- A. **SMAYDA ACRES:** The request is to create two lots from Tax Parcel D24 (MSB Waiver #93-31-PWm), to be known as **Smayda Acres**, containing 9.76 acres +/- . The property is located directly west of N. Witherspoon Road, directly east of N. Tranquility Lane, and north of E. Maud Road; within the SE ¼ Section 1, Township 17 North, Range 02 East, Seward Meridian, Alaska, (Tax ID# 17N02E01D024). In the Butte Community Council and in Assembly District #1. (*Petitioner/Owner: HLS/Tom & Lisa Smayda, Staff: Chris Curlin, Case #2023-137*)

STAFF REVIEW AND RECOMMENDATIONS  
PUBLIC HEARING  
DECEMBER 6, 2023

ABBREVIATED PLAT: SMAYDA ACRES

REVIEWED BY: CHRIS CURLIN CASE #: 2023-137

A PLAT OF  
SMAYDA ACRES  
A SUBDIVISION OF  
PARCEL 4  
MSB WAIVER RES. 93-31-PWm  
(93-115W)

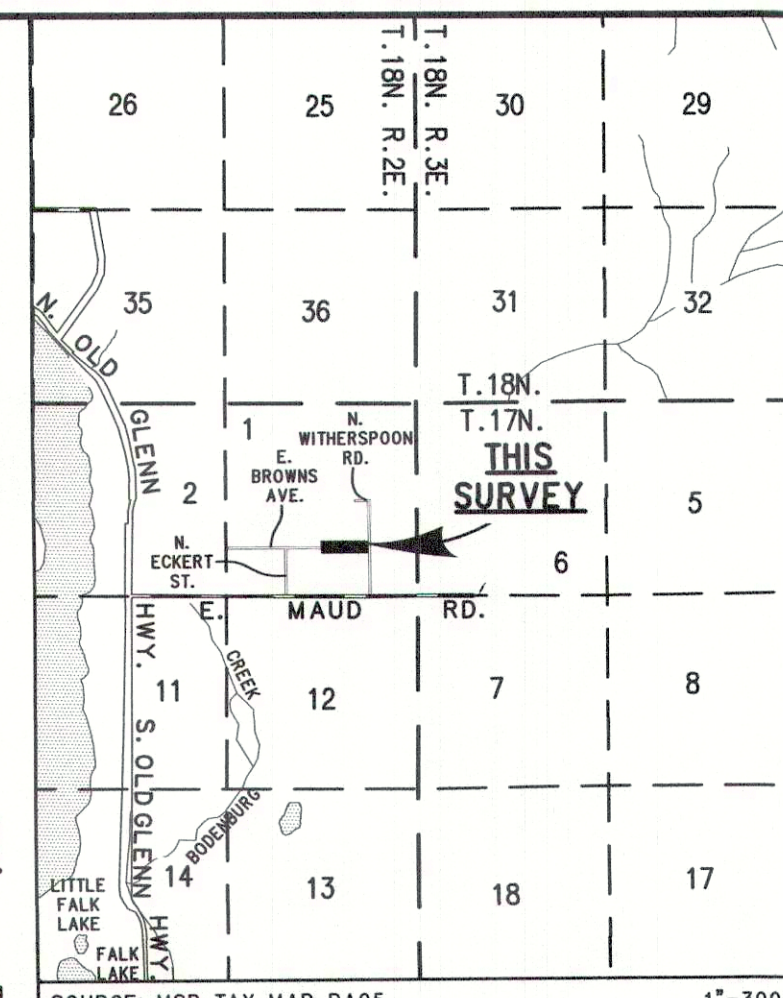
DPW Pre-design and Engineering (**Exhibit D**) notes a plat note to be added stating that if Lot 2B is further subdivided, Browns Avenue will need to be upgraded to residential standards.

Add a note on the plate that if Lot 1 is resubdivided, Brown's Avenue will need to be upgraded to residential standards.
